Facility: Armory Sports Center

Address: 701 E. Ash Street Date of Survey: 01/08/10 & 05/25/10

The Armory Sports Center is a downtown recreation facility located within an old three-story renovated Armory building. All floors are accessible via an elevator. The lower level Exercise/Program Room also supports daycare and after-school activities for children.

RECOMMENDED LOCATION FOR NEW ADA PARKING SPACES

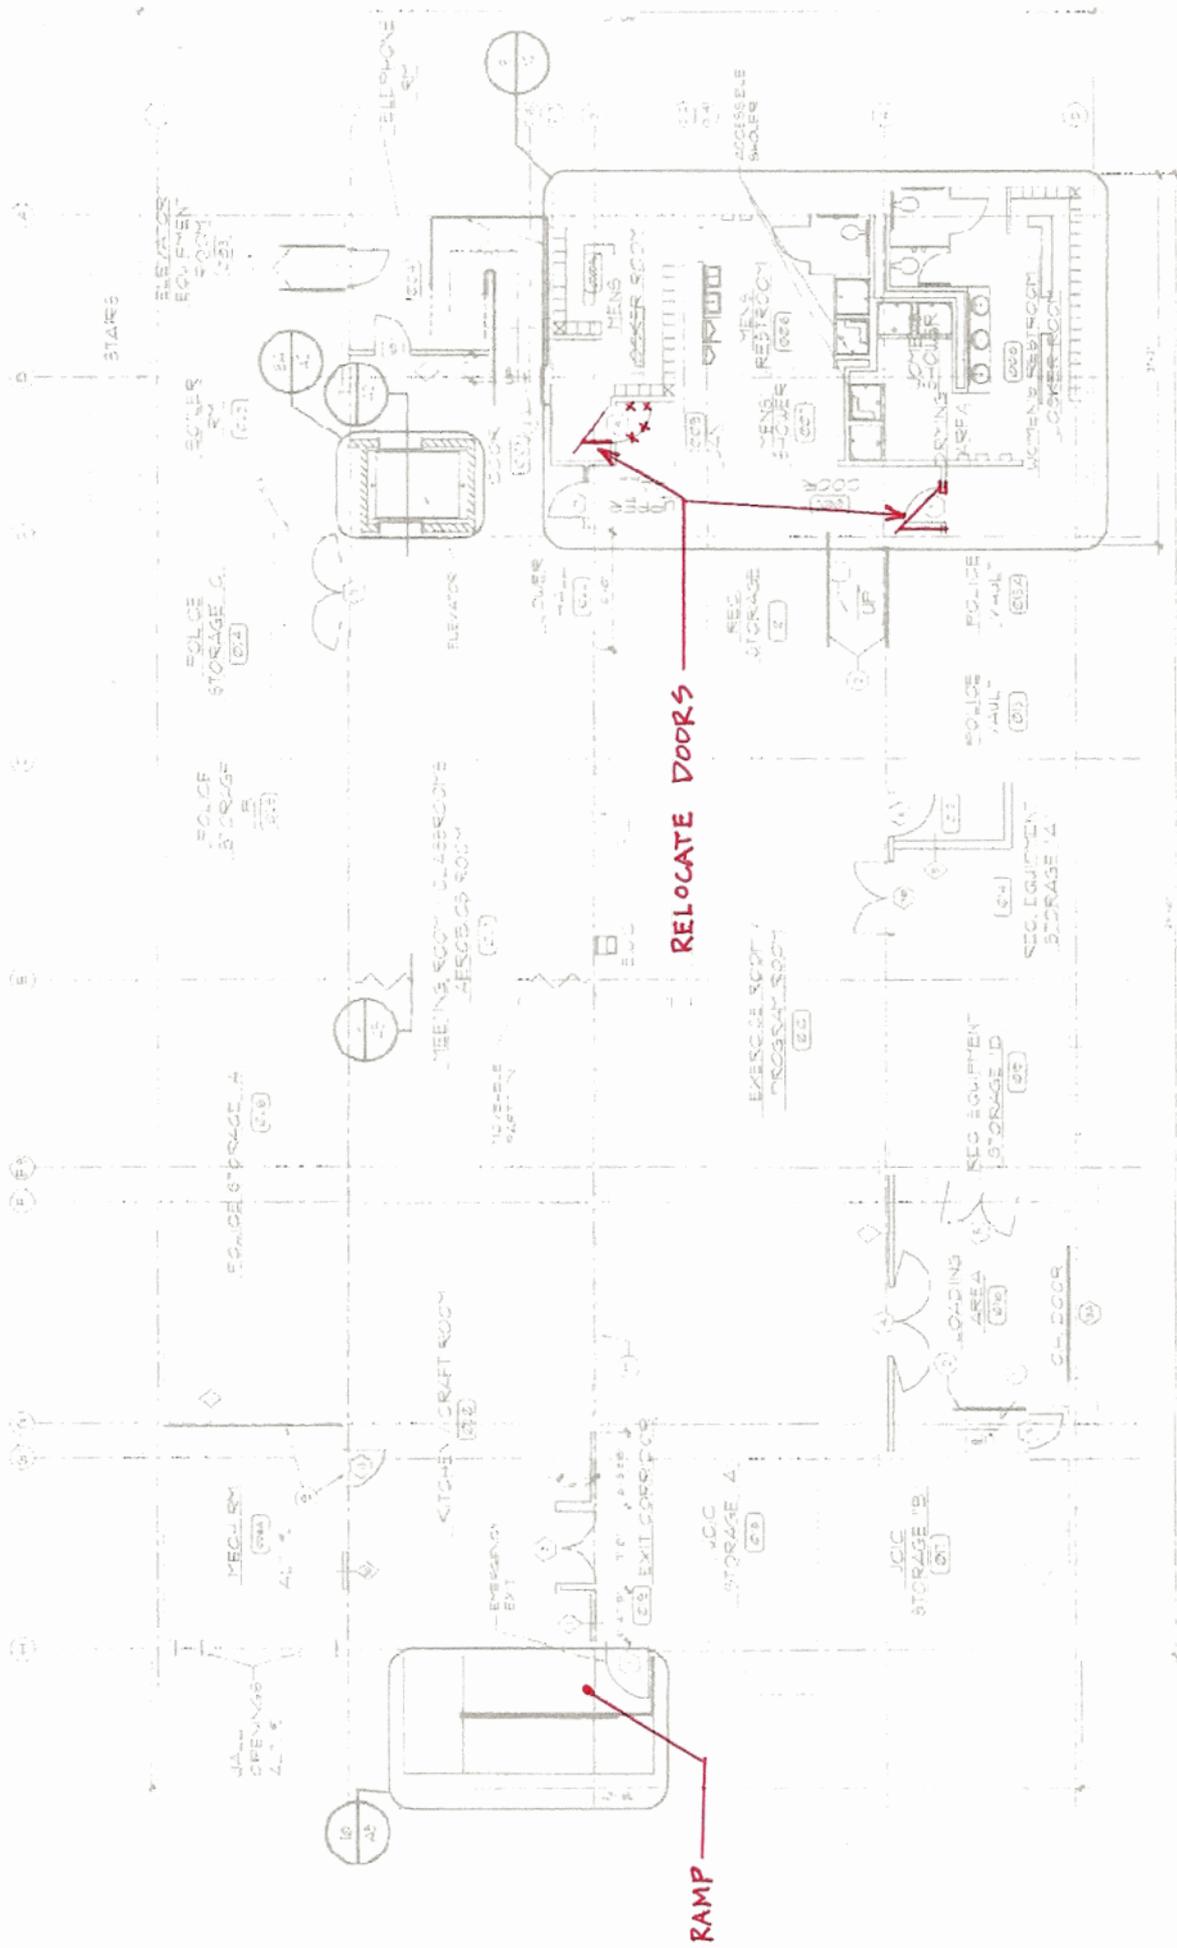
- Parking lots located to the east and north of the building are both “permit parking only” lots, but Saturday parking is free. There is one non-permit van accessible parking space at the SE corner of the building that meets ADAAG. With a total of 187 permit spaces (per the City of Columbia Parking Inventory List dated 10/21/09), ADAAG 4.1.2 requires 6 accessible parking spaces with a minimum of one of those required spaces being van accessible. Therefore, 5 additional accessible parking spaces should be added to the permit parking lots adjacent to the building. There are existing spaces located in the SW corner of the east lot that could easily be converted to accessible spaces as the slopes of those existing spaces are close to required maximum slope of 2% and should require only minimal asphalt modification/repairs and the addition of parking signs and re-striping. (Note: Most spaces in the east lot exceed the 2 % slope requirement; additionally, several spaces could be developed in the north parking lot, but the door on that side of the building appears to be mainly for employee access and emergency egress as the door is locked from the outside during regular hours of operation.)

GROUND FLOOR - NEW WORK
SCALE 1/8" = 1'-0"

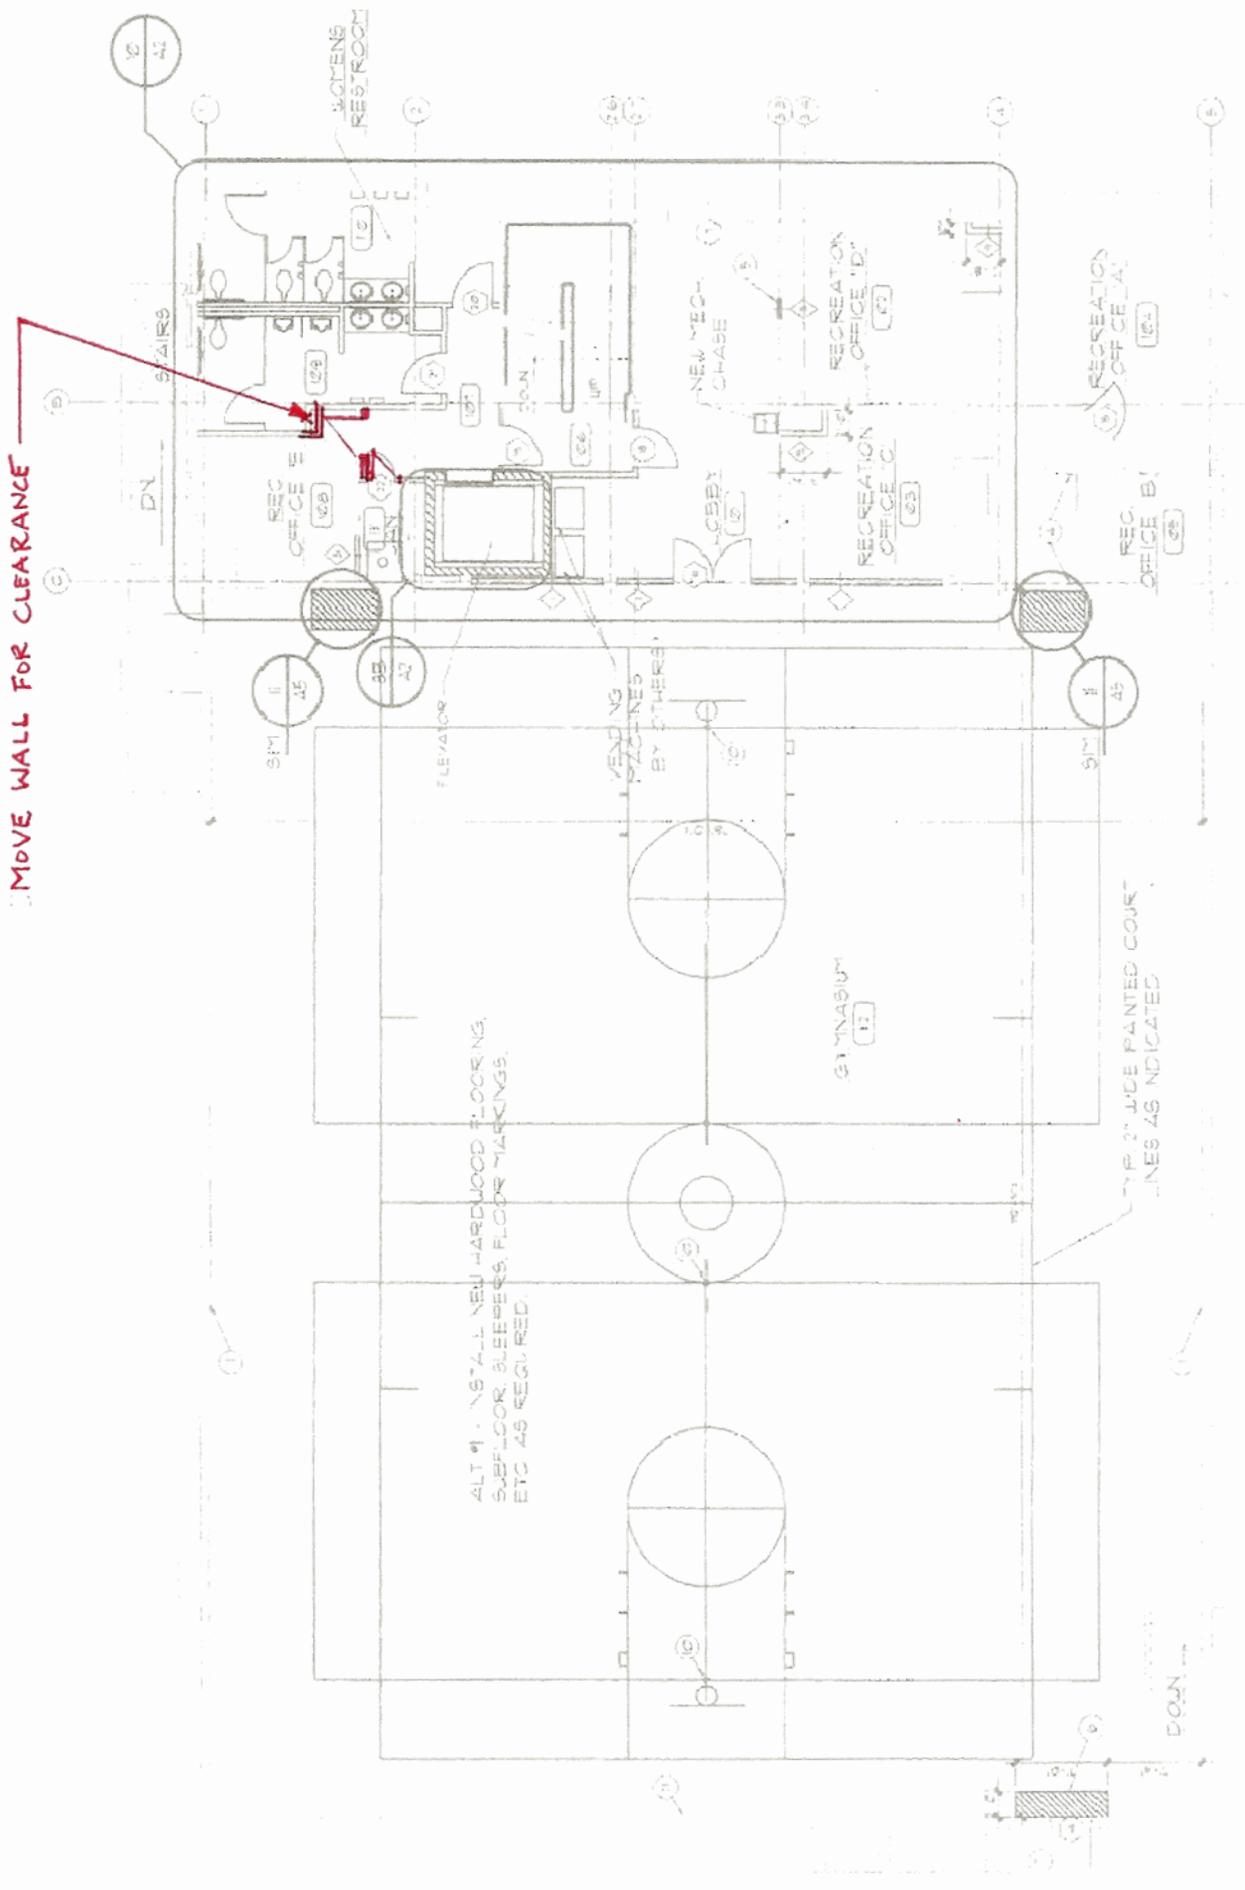
- Door swings out into alcove that does not provide proper maneuvering clearance (41" depth provided, 48" depth required) per ADAAG 4.13.6 & Fig. 25 (c). Remove existing door and frame and reinstall existing frame modified as needed or install a new frame for reinstallation of the existing door so that it swings inward and is hinged on the north side jamb. Existing door closer would need to be adjusted to be operable with 5 lbs. of force or less. Other (more expensive) option is to install an automatic door operator at this door. **Estimated Cost: \$550.00**

- Door swings out into corridor and does not provide proper latch side clearance (16.5" provided, 18" required) per ADAAG 4.13.6 & Fig. 25 (a). Remove existing door and frame and cut out existing wall to the north to allow reinstallation of existing door and frame in order to obtain minimum 18" side clearance. Existing door closer would need to be adjusted to be operable with 5 lbs. of force or less. Other (more expensive) option is to install an automatic door operator at this door.
Estimated Cost: \$773.00

FIRST FLOOR - NEW WORK
SCALE 1/8" = 1'-0"

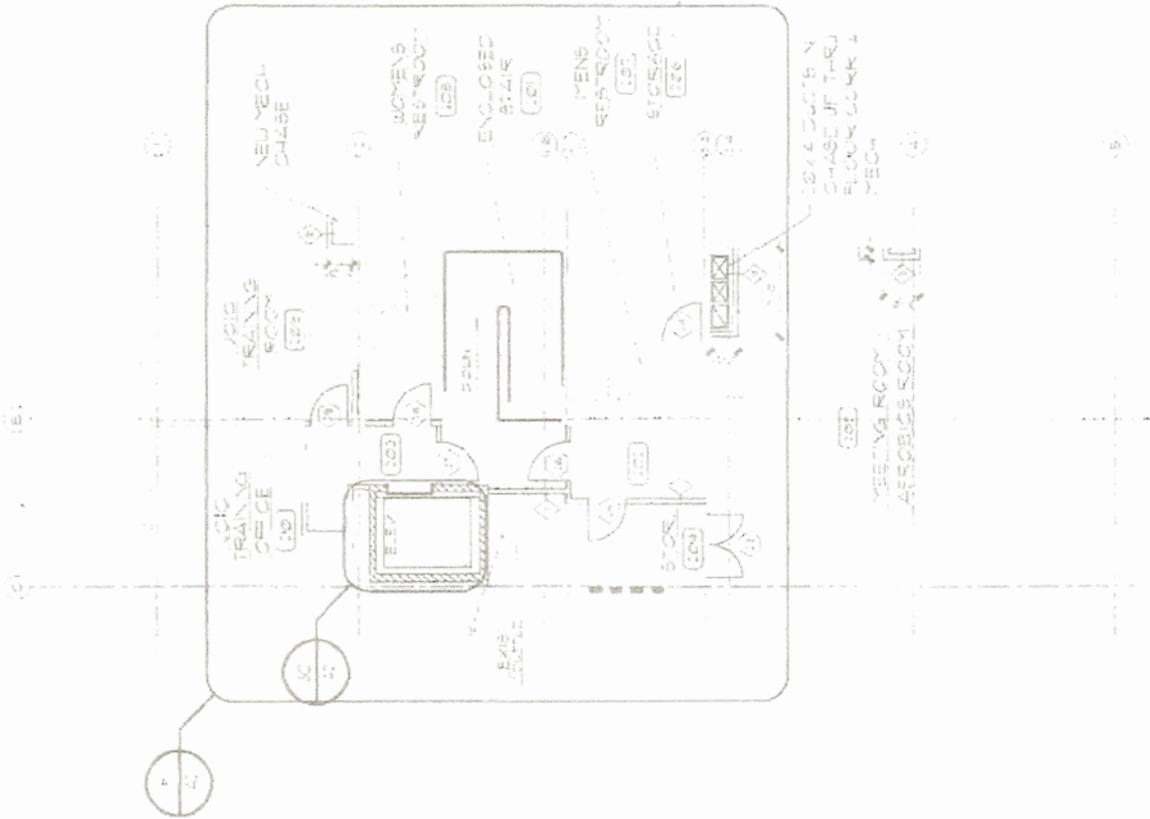
- Accessible toilet stall door approach required maneuvering space depth is only 36" due to location of wall (see photo 7). In order to obtain minimum required 48" depth at door to meet ADAAG Fig. 25 (a), the wall that separates the Restroom from Office 108 would have to be modified which would also require the door into Office 108 and likely the door into Janitor Closet 111 to also be relocated.
Estimated Cost: \$936.00

MOVE WALL FOR CLEARANCE
